Airworthiness Directive Schedule

MD Helicopters 369 Series, 500N and Kawasaki-Hughes 369 Series

26 March 2020

Figure 1 - Inspection Location

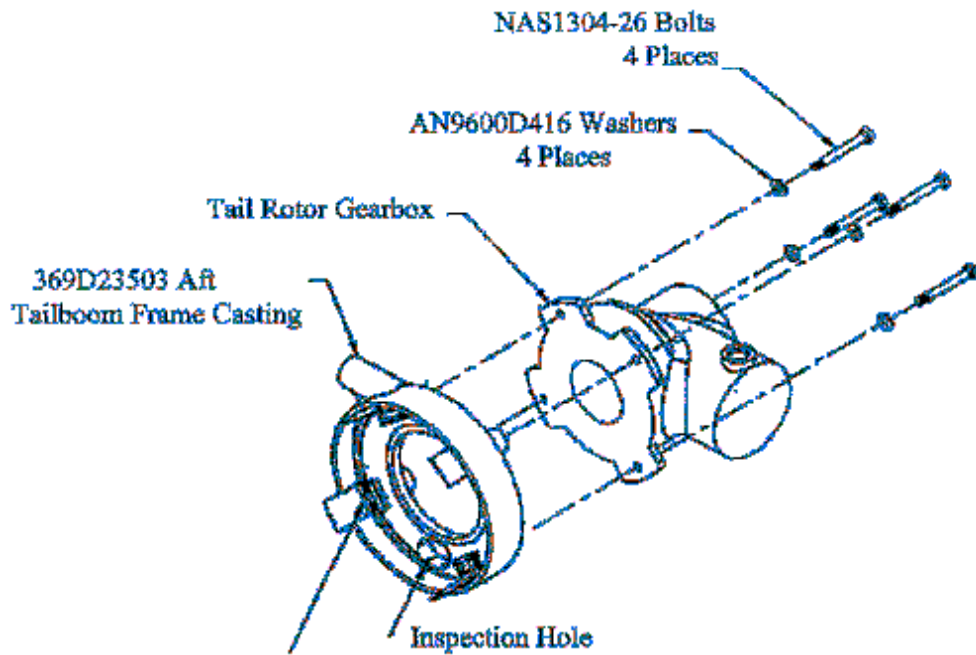
1. Determine the P/N of each tail rotor gearbox attaching bolt. If the P/N cannot be determined or if the bolt is not P/N NAS1304-26, replace with bolt, P/N NAS1304-26, before further flight. Torque the bolt to 100-110 in-lbs and apply a slippage mark.

2. Remove the tailboom control rod and determine the number of bolt threads protruding from each nutplate on the internal surface of the aft tailboom frame casting, P/N 369D23503, as shown in Figure 1 of this AD. At least one thread must protrude. If more than four threads protrude, add an additional washer, P/N AN960D416, under the bolt head. Torque the bolt to 100-110 in-lbs, and reapply a slippage mark.
